From: Laura Wareing
Sent: 08 October 2024 12:24
To: Danielle Cooper
Subject: RE: 14-16 St Ann St

FURTHER HIGHWAYS COMMENTS 8TH OCTOBER 2024:

The updated plan ('Proposed Site Plan - P.L(00)101/F') details the removal of the tables and chairs from the proposal and relocation of cycle stands. The relocation of the cycle stands are required in order to enable access to the building for the delivery of cars (discussed in Highways initial comments). It is noted that the existing number of cycle stands will be retained as part of the proposals. In principle Highways would accept the relocation of the stands. This will be subject to detailed design at S278 stage.

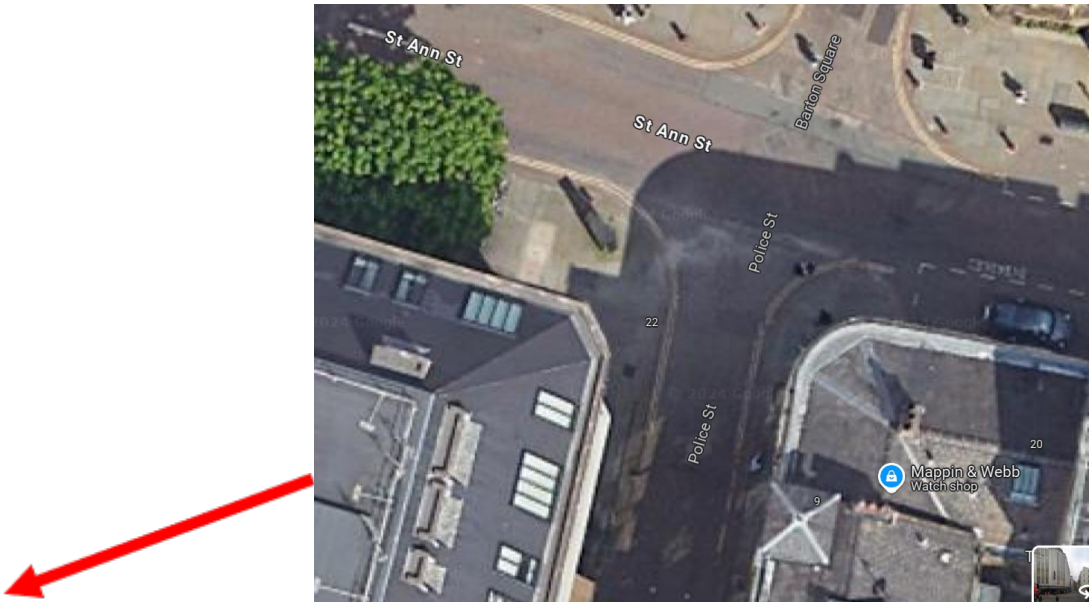
In relation to the bicycle stands being temporarily removed, these are secured into the ground and as such it will not be possible to temporarily remove them due to the disrupt this would have on pedestrian and highway safety. It is requested that the cycle stands stay in their existing location. MCC Highways would have concerns with these moving to the proposed location due to the existing infrastructure within that location currently.

It is noted that access is required at the site frontage for the delivery of vehicles. It is suggested that the applicant considers accessing the new cars into the unit via the junction of Police Street / St. Ann Street (see below). In order to fully assess this, it is requested that the applicant demonstrate that this movement is possible via swept path analysis.
